**DEPARTMENT OF TRANSPORTATION**

Contract #: 04-0120F4Cty: SF/ALA Rte: 80 PM: 13.2/13.9File #: 69.25B

**QUALITY ASSURANCE -- NON-CONFORMANCE REPORT**

**Reference Description:** Missed UT indication by QC on Segment 10AE Side Plate to Side Plate Weld**Description of Non-Conformance:**

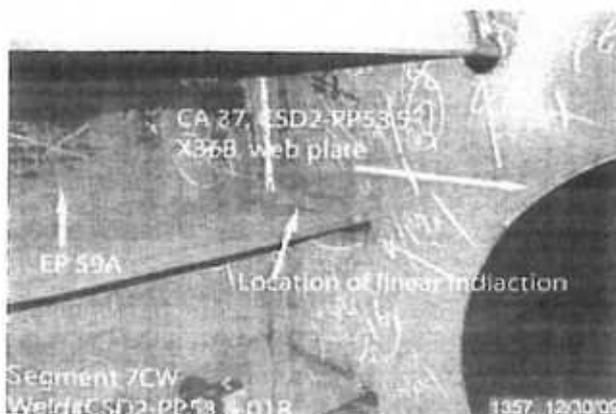
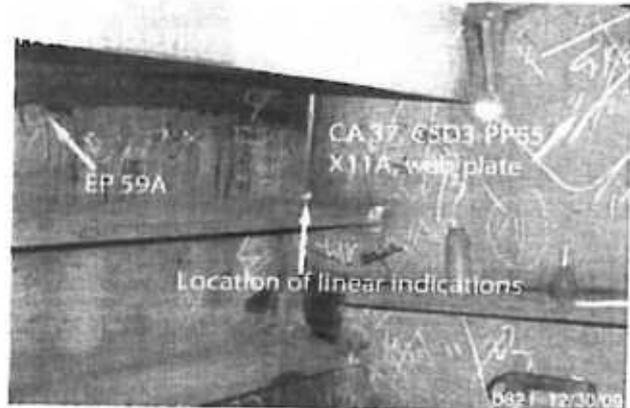
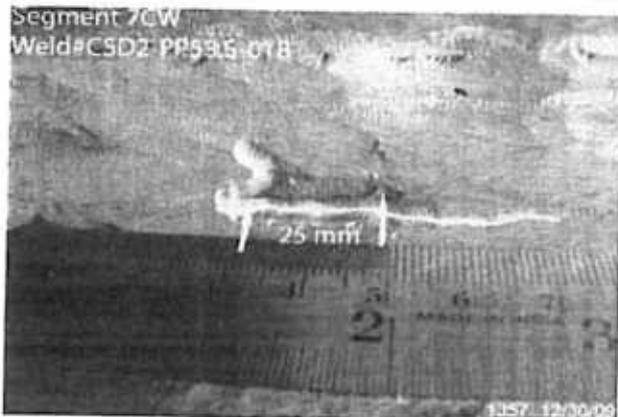
During the Quality Assurance Magnetic Particle Testing (MT) review of welds located on Segment 7CW, this Quality Assurance Inspector (QA) discovered the following issues:

- Two (2) Longitudinal linear indication measuring approximately 20mm and 25mm in length.
- The welds are identified as: CSD3-PP55-025, 026 (30 mm) and CSD2-PP53.5-018 (25 mm).
- The welds are a Fillet Weld type joining the Edge Plate (EP59A) stiffeners to Corner Assembly (CA37A) web plates.
- The OBG 7CW segment is located at in front of Blast Shop.

The Notice of Witness Inspection Number (NWIT) is 004947. The indication is located inside the area that has been previously tested and accepted by ZPMC Quality Control (QC) personnel. ZPMC's QC personnel are required to perform twenty five (25%) percent MT inspection of this weld.

AWS D1.5 (02) Section 6.26.2 – “Welds that are subject to MT in addition to visual inspection shall have no cracks.

Submit a repair procedure to the engineer for approval. Provide the ZPMC MT technician additional training and equipment to ensure these types of indications are identified in the future.

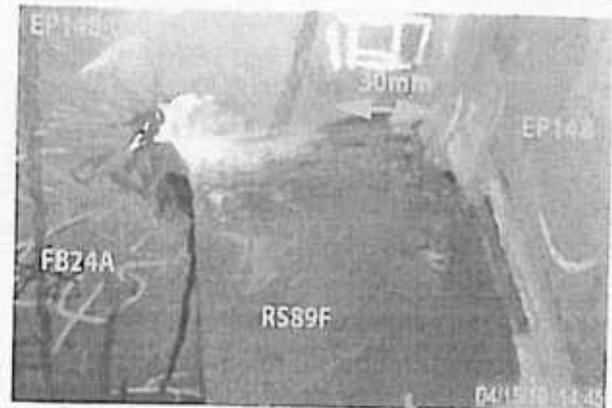
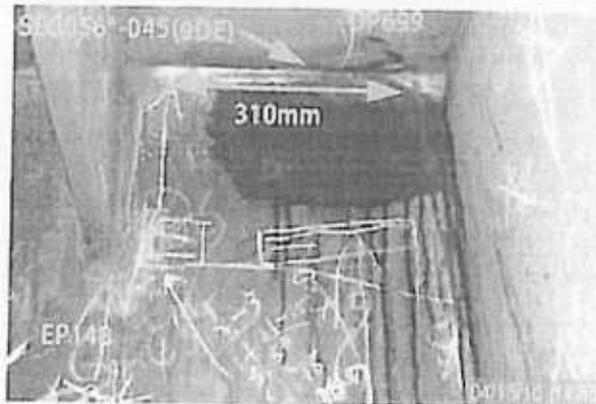
During the Quality Assurance (QA) Ultrasonic Testing (UT) review of welds located on Orthotropic Box Girder (OBG) Segment 9DE, this QA Inspector discovered the following issues:

- Two (2) longitudinal linear indications measuring approximately 310mm and 30mm in length.
- The indications dBs rating are +6 and +4.
- Material thickness is 18mm.
- The depth of the indications is approximately 11mm and 13mm.
- The welds are identified as SEG056\*-045 at Panel Point (PP) PP81.5 and EP148-022 at PP 81.
- The welds are designated as Seismic Performance Critical Material (SPCM).
- The indications are clearly marked on or near the weld.
- The Y distance for the indications are 50 mm from PP81.5 and 0 mm from EP148A.
- Weld SEG056\*-045 is a Complete Joint Penetration (CJP) Corner joint, joining the Edge Plate PL1336C (SPCM) to Deck Plate PL1314A (Non SPCM).
- Weld EP148-022 is a Complete Joint Penetration (CJP) "T" joint, joining the Edge Plate stiffener RS89F (Non SPCM) to FB24A plate PLX24D (SPCM).
- Segment 9DE is located outside of Paint shop.

The Notice of Witness Inspection (NWIT) No. is 005523. The indication is located in an area previously tested and accepted by ZPMC Quality Control (QC) personnel. As per the contract documents, ZPMC's QC personnel are required to perform hundred (100%) percent UT inspection of this weld.

AWS D1.5-02 Section 6; Table 6.3 specifies a class "A" indication as having a rating of 10dBs and under for material thicknesses 8mm through 20mm.

Propose a resolution for the identified non-conformance to prevent future occurrences. A response for the resolution of this issue is expected within 7 days.

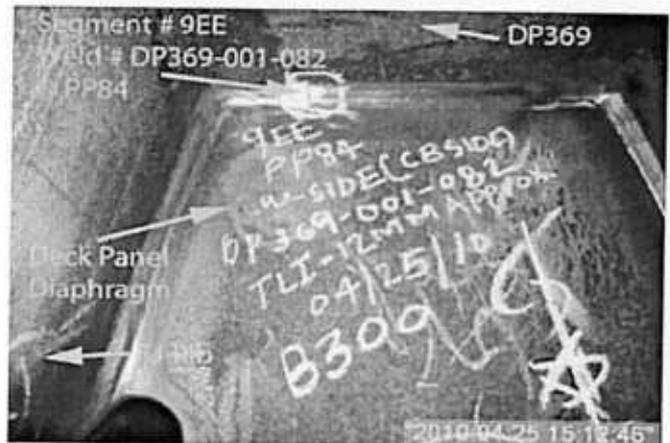
-One (1) Transverse linear indication measuring approximately 10 mm in length.

-Weld is a Complete Joint Penetration (CJP) Weld joining the Deck panel Diaphragm to U-Rib.

-Weld Identification number is DP477-001-137 @ Panel Point-083.

-Deck panel Diaphragm is identified as X1E.

-U-Rib is Identified as R18D.

-Location Panel Point (PP83).

Propose a resolution for the identified non-conformance with revised procedures to prevent future occurrences. A response for the resolution of this issue is expected within 7 days.

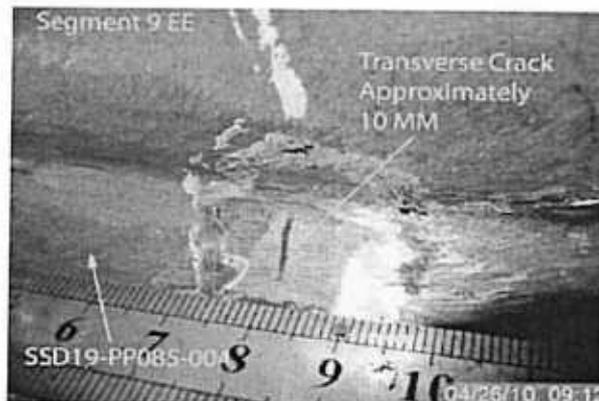
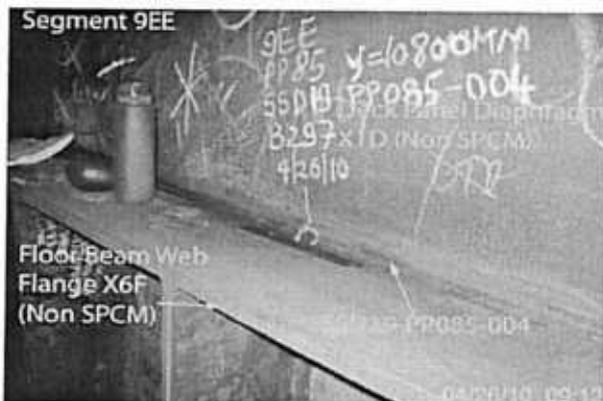
During the Quality Assurance (QA) Magnetic Particle Testing (MT) review of welds located on Segment 9EE, this QA Inspector discovered the following issues:

- One (1) transverse crack measuring approximately 10mm in length in the fillet weld joining the Deck Panel Diaphragm (X1D) to Floor Beam Web Flange (X6F) at panel point 85.
- The Y location is 10800mm from the termination of the weld on the crossbeam side.
- The indication is clearly marked near the weld.
- The weld is identified as: SSD19-PP085-004.
- OBG segment 9EE is located north of the blast shop.
- The Notice of Witness Inspection Number (NWIT) is 005583. The indication is located within the area that has been previously tested and accepted by ZPMC Quality Control (QC) personnel.

AWS D1.5 (02) Section 6.26.2 – “Welds that are subject to MT in addition to visual inspection shall have no cracks.

Propose a resolution for the identified non-conformance with revised procedures to prevent future occurrences. A response for the resolution of this issue is expected within 7 days.

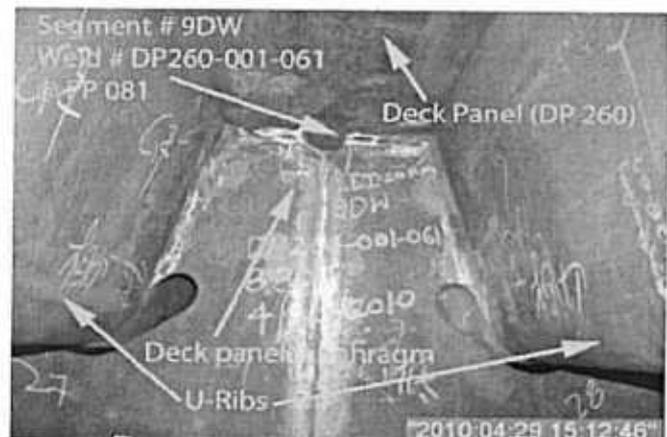
Procedural  Procedural  **Description:** Missed MT Indication by QC

**Reference Description:** Missed MT indication by QC on Segment 9DW Deck Panel to Diaphragm

Propose a resolution for the identified non-conformance with revised procedures to prevent future occurrences. A response for the resolution of this issue is expected within 7 days.

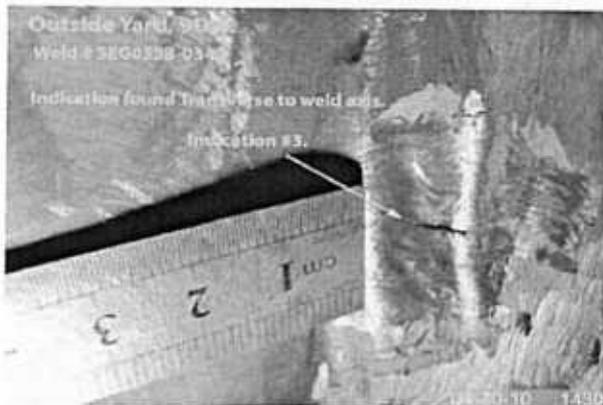
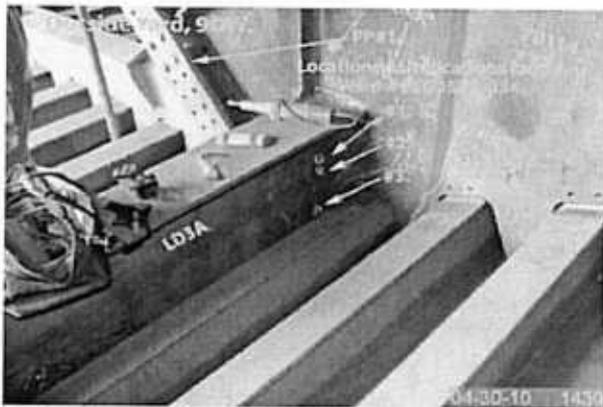
On April 30, 2010:

- Three transverse linear indications, one measuring approximately 9mm and two indications measuring approximately 5mm in length at Longitudinal Diaphragm (LD) LD3A to Floor beam (FB) FB11A.
- Weld is identified as SEG055B-034 and designated as a Fracture Critical Weld (FCW).
- The weld is a 14mm Complete Joint Penetration (CJP) T-joint joining LD 3A shear plate identified as X39B to FB web plate identified as X47C (Seismic Performance Critical Material SPCM).
- The indications are clearly marked on the material.

On May 1, 2010:

- One (1) Longitudinal linear indication measuring approximately 18mm in length.
- The Y location is 7mm from the cope hole.
- The indication is clearly marked on the material near the weld.
- The weld is identified as: CSD9-PP81-062.
- The weld is designated as Seismic Performance Critical Member (SPCM).
- The weld is located at PP81 (Counter Weight Side).
- The weld is a Fillet Weld T-joint joining the Corner Assembly Diaphragm identified as X11B (SPCM) to Side Plate identified as SP658 (SPCM).
- OBG segment 9DW is located west of Bay #14.
